# UNITED STATES PATENT AND TRADEMARK OFFICE

10/647,304

James C. Beattie

<b>Office Action Summary</b>	<b>Application No.</b>	<b>Applicant(s)</b>	
	10/647,304	BEATTIE, JAMES C.	
	<b>Examiner</b>	<b>Art Unit</b>	
	Vinh T. Luong	3682

**ATTACHMENT**

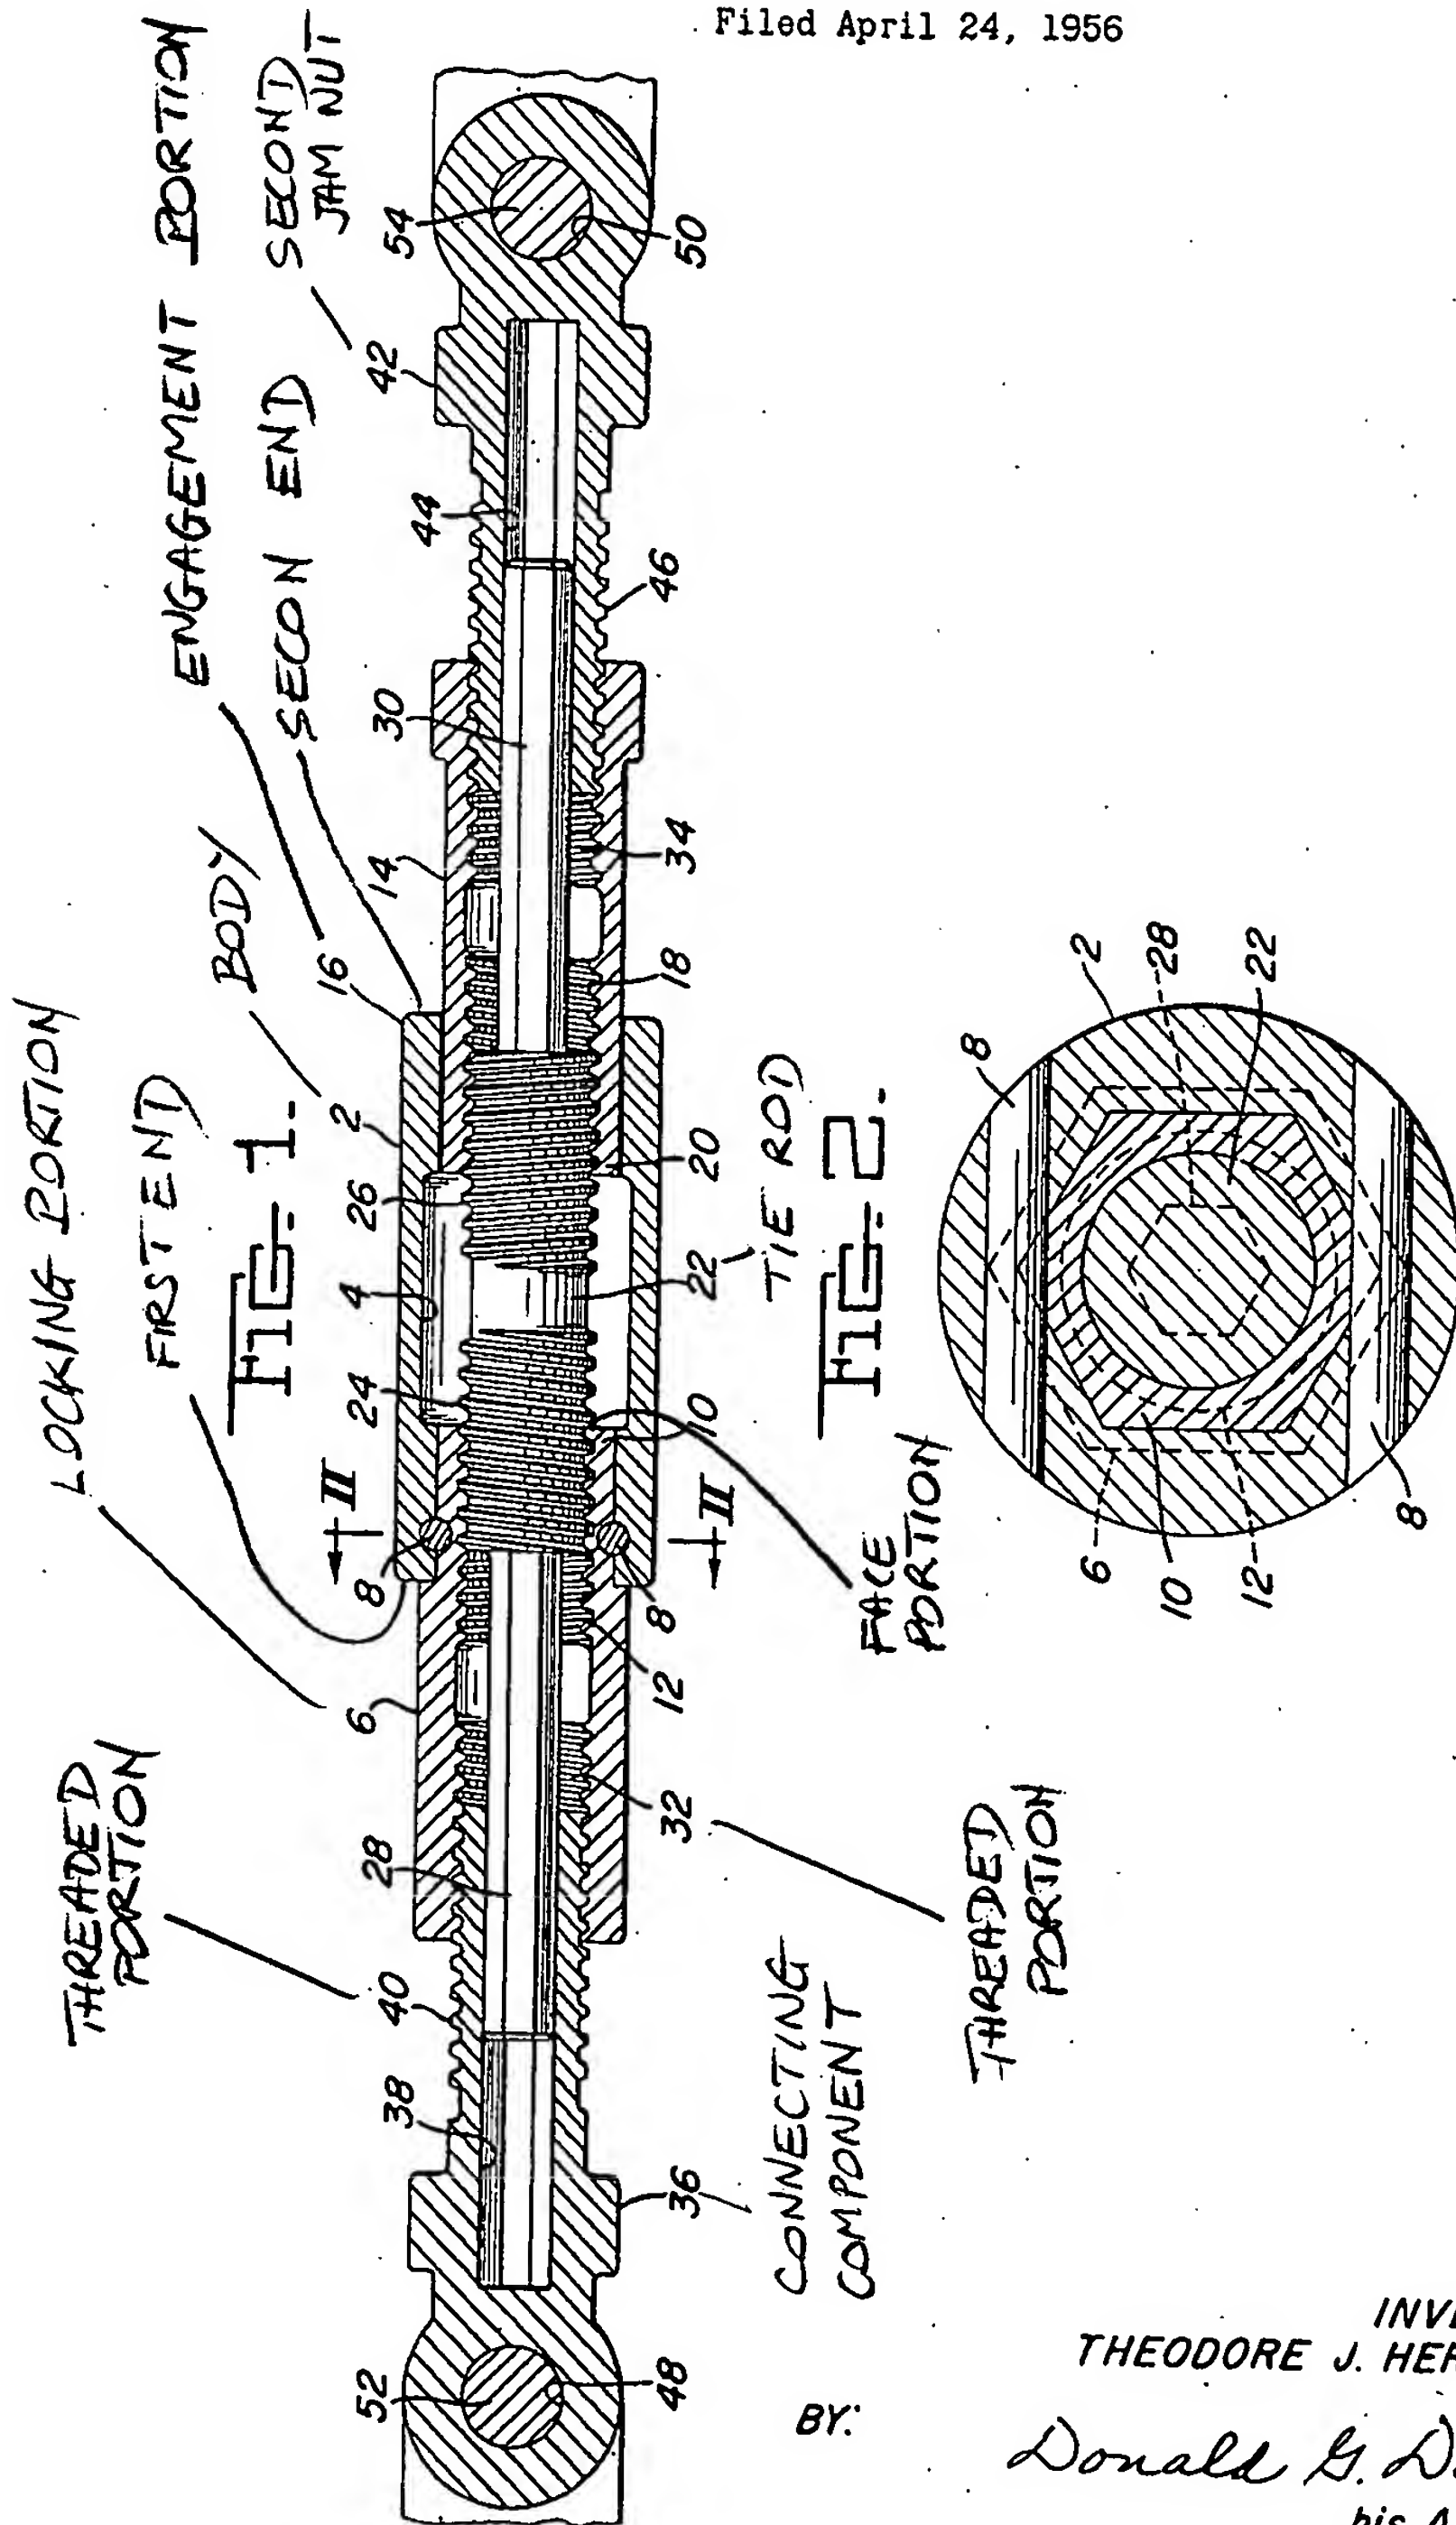
11. Claims 1-11, as best understood, are rejected under 35 U.S.C. 103(a) as being unpatentable over Herrmann (USP 2,813,733).

an elongated tubular body 2 having a first end and a second end (see Attachment), the body 2 having an axial internal bore 4 constructed and arranged to receive a portion of an elongated tie rod 22;

a locking portion 6 connected to the tubular body 2, the locking portion 6 positioned at the first end of the tubular body 2 and having a threaded bore 12 constructed and arranged to threadingly engage an externally threaded portion 40, 32 of a connecting component 36 *non-threadingly* engaged with the tie rod 22, the locking portion 6 having a face portion (at 10 in Fig. 1. See Att.) constructed and arranged to engage a portion 24 of the tie rod 22 in a manner so as to lock the connecting component 36 with respect to the tie rod 22 as the locking portion 6 is rotated in a first direction about the threaded portion 40, 32 of the connecting component 36 and to disengage the same portion 24 of the tie rod 22 so as to unlock the connecting component 36 with respect to the tie rod 22 as the locking portion 6 is rotated in a direction opposite the first direction about the threaded portion 40, 32 of the connecting component 36;

an engagement portion 16 connected to the tubular body 2 and spaced distally from the locking portion 6 toward the second end of the tubular body 2, the engagement portion 16 constructed and arranged to be engaged and rotated so as to

remotely rotate the locking portion 6 between the locked and unlocked positions. *Ibid.*, col. 1, line 46 through col. 2, line 68, and claims 1-6.

Herrmann teaches the invention substantially as claimed. However, Herrmann's connecting component 36 is *non-threadingly* instead of threadingly engaged with the tie rod 22.

It is common knowledge in the art to change the non-threaded coupling of Herrmann's connecting component and tie rod to threaded coupling in order to connect the connecting component to the tie rod. The threaded coupling is notoriously well known as seen in Herrmann's threaded coupling 12, 32, *etc.*

Regarding claim 5, the face portion (Att.) of the locking portion 6 lies in a plane perpendicular to an axis of the elongated tubular body 2.
